Re: Maple Village Interim Response – Performance Monitoring Wells

**UNIT E-MAPLE ROAD
 PROPOSED BORING/MONITORING
 WELL LOCATIONS**

Pall Life Sciences
 Scio Twp., Washtenaw County, Michigan
Maple Road Interim Response

PROJECT NO.
 F96502
 ATTACHMENT
1

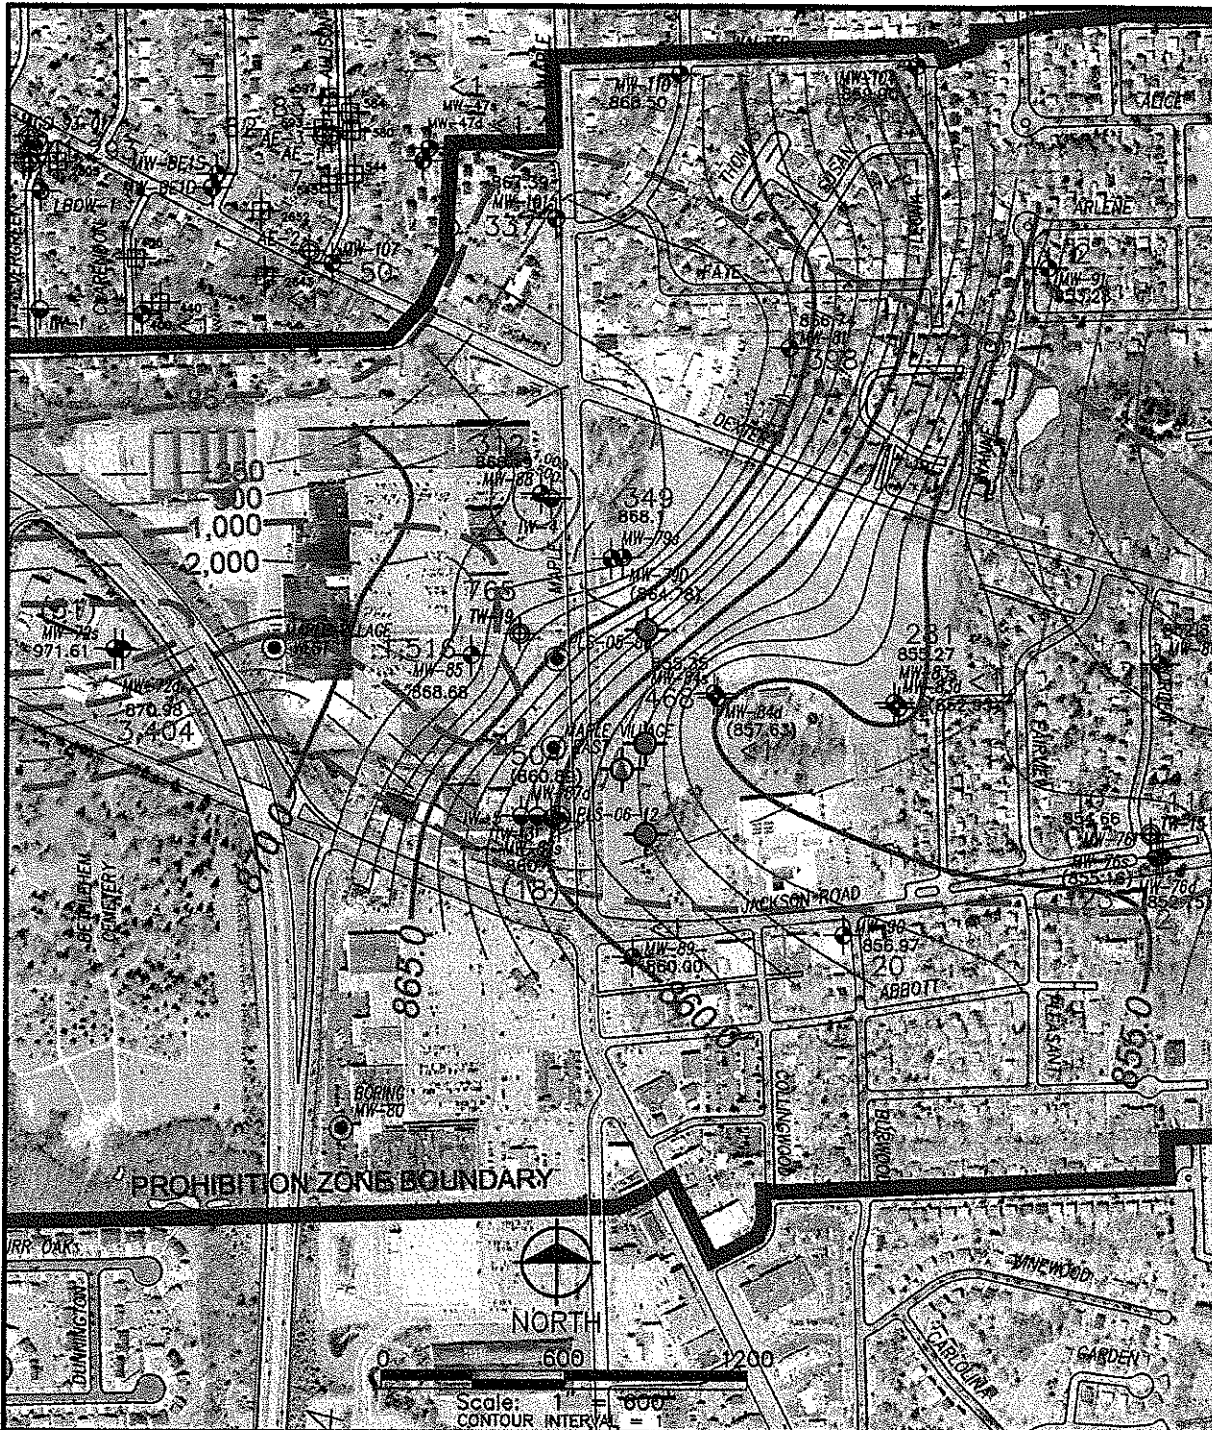
The MDEQ has proposed three well clusters on the east side of Maple Road. The locations of these proposed clusters are shown on Attachment 1. PLS provides the following comments regarding these locations:

- MDEQ MRC-1 — PLS agrees this is a suitable downgradient monitoring location. Minor field adjustments may be necessary to accommodate site-specific conditions (e.g., infrastructure, surface conditions, etc.).
- MDEQ MRC-2 and MRC-3 — PLS does not believe both of these well clusters are needed. PLS believes that MDEQ MRC-2 should be moved to the south and east, and MRC-3 should be eliminated. Alternative locations to the three MDEQ proposed clusters are shown on Attachment 2

PLS' primary justification for moving MDEQ MRC-2 and eliminating MDEQ MRC-3 is as follows:

1,4-Dioxane concentrations at MW-87s and MW-87d never detected levels of 1,4-dioxane over 2,800 ug/L (the highest level detected at this cluster was 1,312 µg/L at MW-87s and 767 µg/L at MW-87d). 1,4-Dioxane concentrations at the Maple Village East boring (installed 7/30/03) were below 2,800 ug/L when that boring was installed (the highest concentration encountered was 856 µg/L). 1,4-Dioxane concentrations at the PLS-05-06 (installed in 8/05) were below 2,800 ug/L when that boring was installed (the highest concentration encountered was 660 µg/L). These data suggest 1,4-dioxane concentrations in the area along Maple Road, south of TW-19, never reached 2,800 ug/L (and in fact, 1,4-dioxane concentrations at these locations never exceeded 50% of 2,800 ug/L). After injection started in this area, the concentrations in MW-87s and MW-87d have decreased and are expected to remain well below 2,800 ug/L as a result of the injection process. Installing a monitoring well hydraulically downgradient of this area (see the attached potentiometric surface map) as proposed by the MDEQ, will provide little value.

Analyses by PLS indicate an effective location for a monitoring well is on the east side of Maple Road, south of MW-85 and north of IW-5 (the southern injection well). Available water quality data, including data from Maple Village East, suggests the longitudinal axis of the plume is positioned north of the Maple Village East boring and in the capture of TW-19. Nevertheless, one could argue that 1,4-dioxane could migrate south of MW-85 and north of the injection well. Obviously, the plume will not migrate toward IW-5. PLS proposes that a well be positioned in the area south of MW-85 and north of IW-5. A proposed location for this well is shown on Attachment 1. Installing another well south of this location is not justifiable. Additionally, MW-89 serves as an effective well to monitor for 1,4-dioxane moving south of the IW-5 area.

Wells installed at the locations proposed by PLS would result in a maximum well spacing of approximately 600-feet. This spacing would be between the proposed southern monitoring well and MW-89. The spacing between the wells to the north would be considerably less. PLS would also like to note that, although slightly further east than perhaps ideal, MW-84s/d is also strategically positioned as a downgradient monitoring location.

Upon your approval, PLS will complete the installation of the two proposed well clusters prior to the end of this calendar year, providing access to the drill sites can be worked out with the City of Ann Arbor.
